**REQUEST FOR TENDER
AFRICA RESTAURANT ROOF REPLACEMENT
RFT # 11 (2013-03)**

ADDENDUM # 3

Addendum No.1

Project:	2013 Roof Rehabilitation Program	Page No:	1 of 1
Facility:	Toronto Zoo-Africa Pavilion Restaurant	Date:	March 22, 2013
Address:	361A Old Finch Avenue Scarborough, Ontario, M1B 5K7	IRC Ref. No:	MR11-037SP-06049
		Client Ref. No:

R1-R

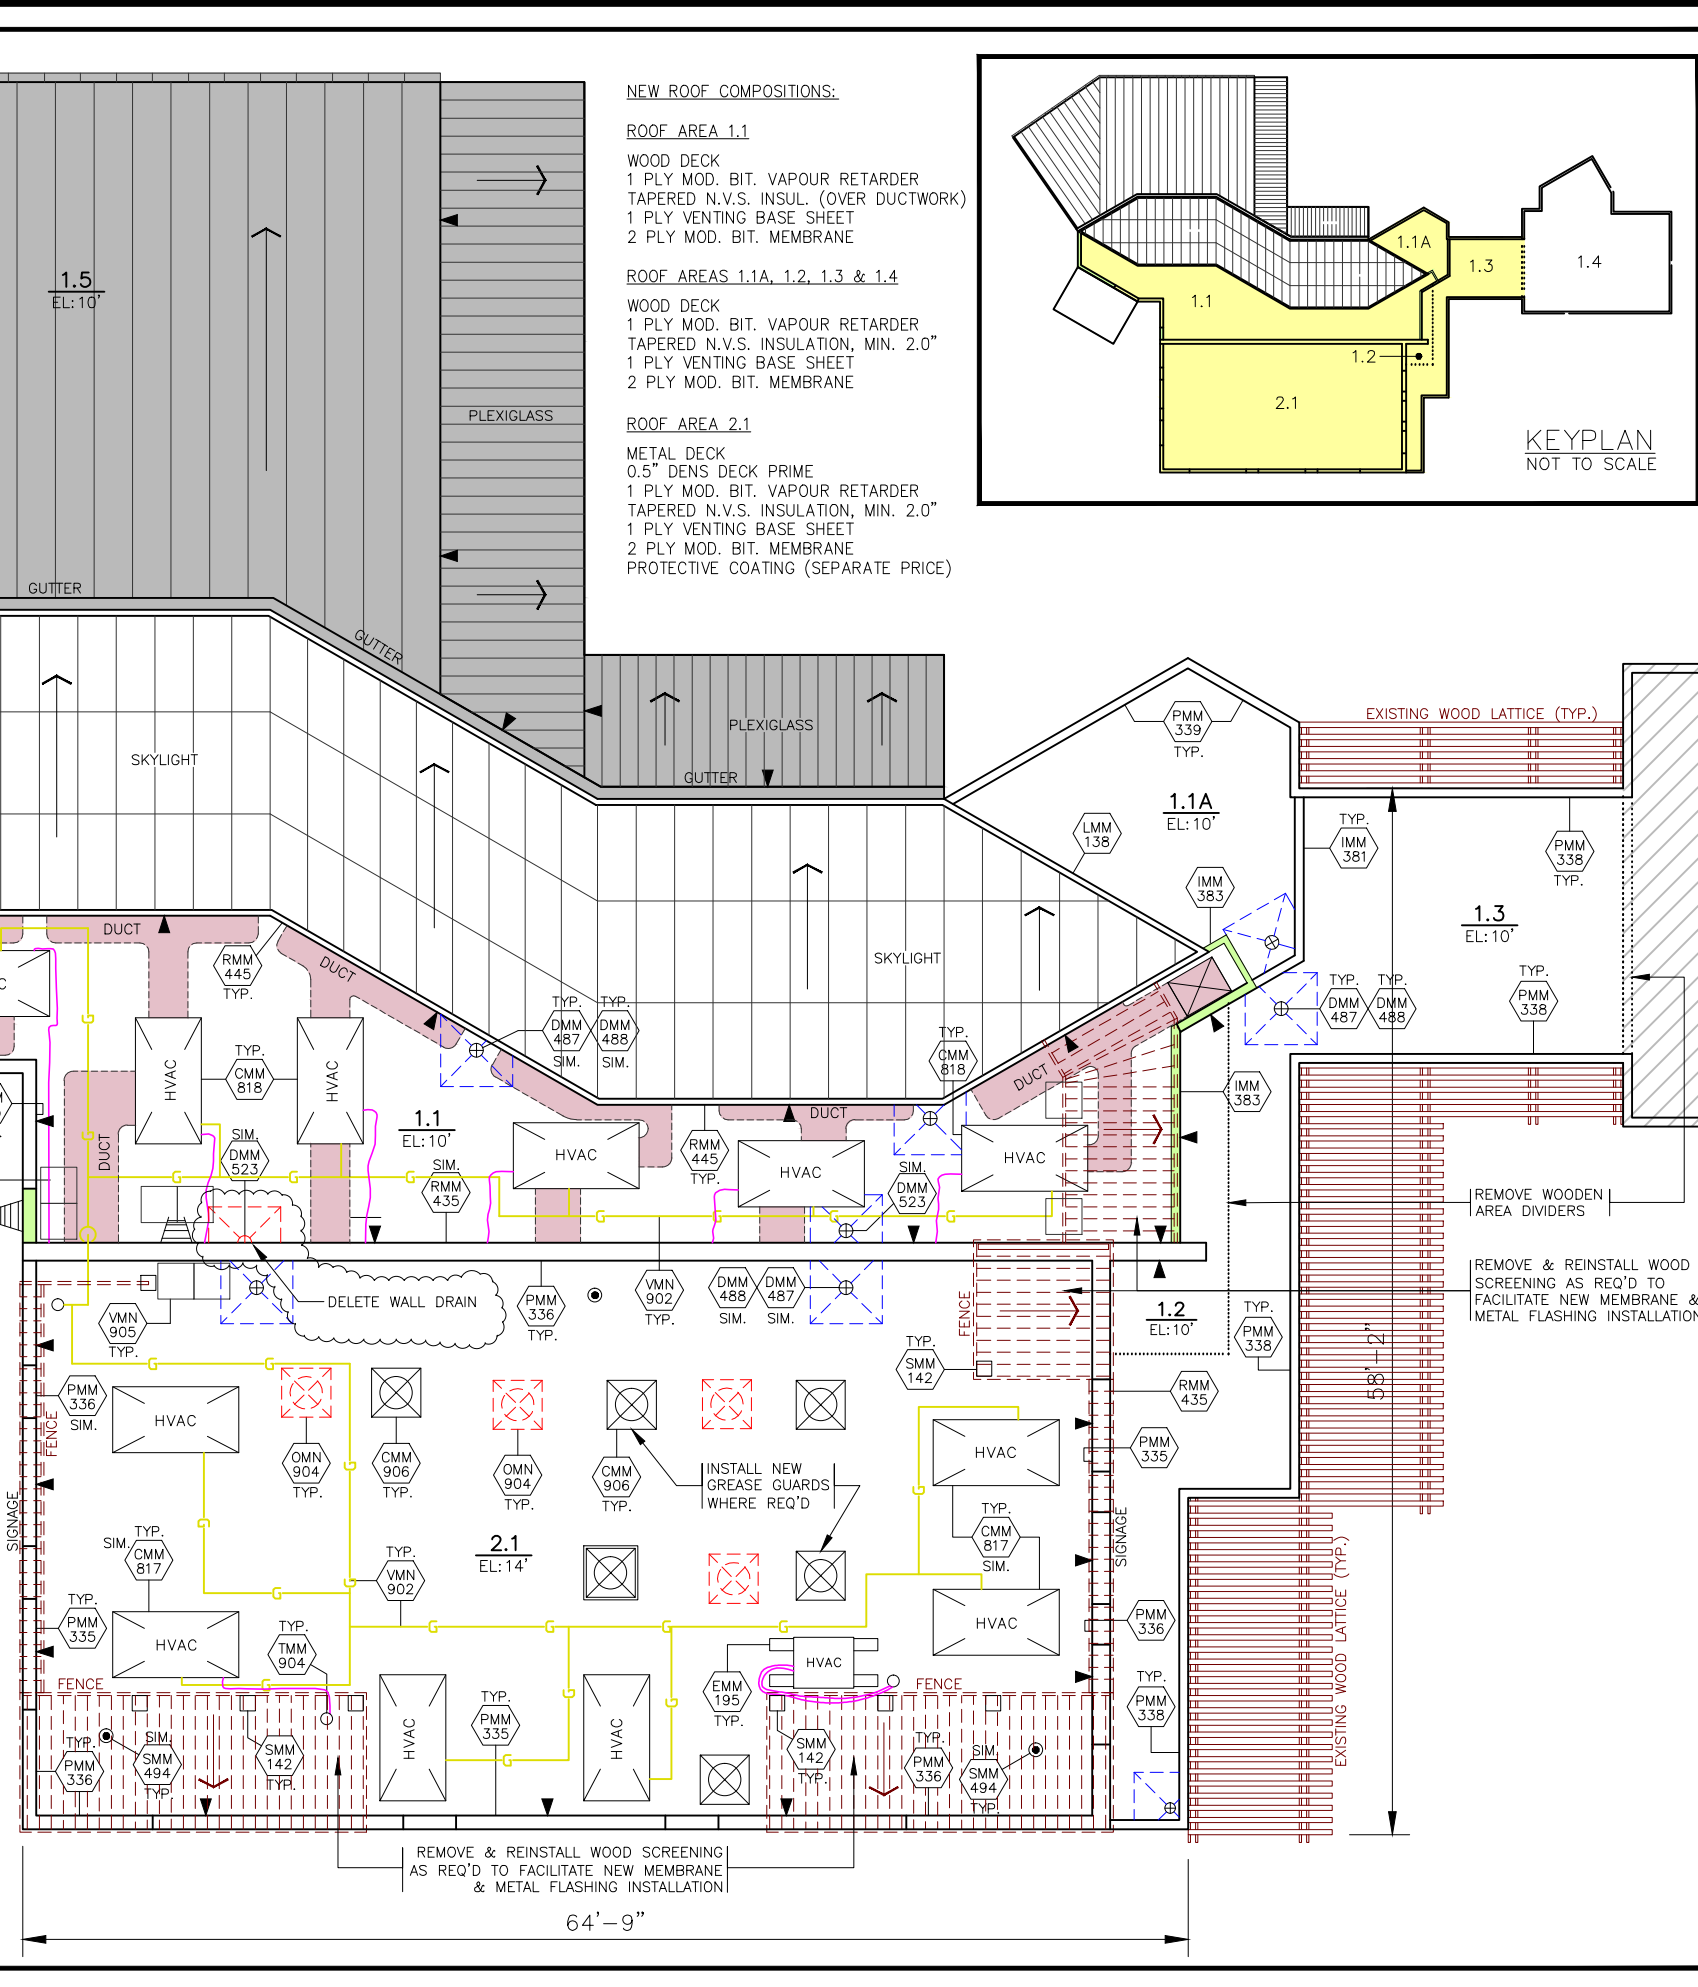
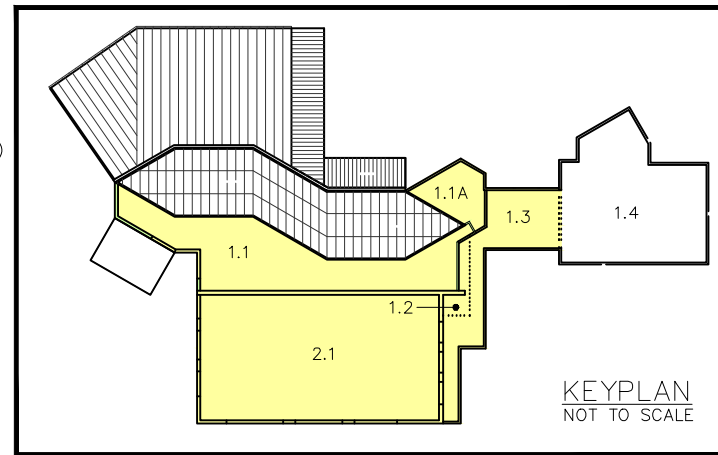
- 1.1 On Roof Area 1.1: Delete and seal-off wall drain, next to ladder in South-West corner in south-west corner, as indicated on enclosed revised roof plan drawing R1-R.
- 1.2 On Roof Area 1.1: At four (4) existing roof drain locations, provide new copper roof drain inserts with custom-built extra long drain stems to suit height of new tapered insulation and sumps. Use U-flow connectors to engage seal to existing storm water drainage.
- 1.3 On Roof Area 2.1: Delete four (4) exhaust fans as indicated on enclosed revised roof plan drawing R1-R. Refer to enclosed detail OMN904 for deck closure at deleted curb locations.
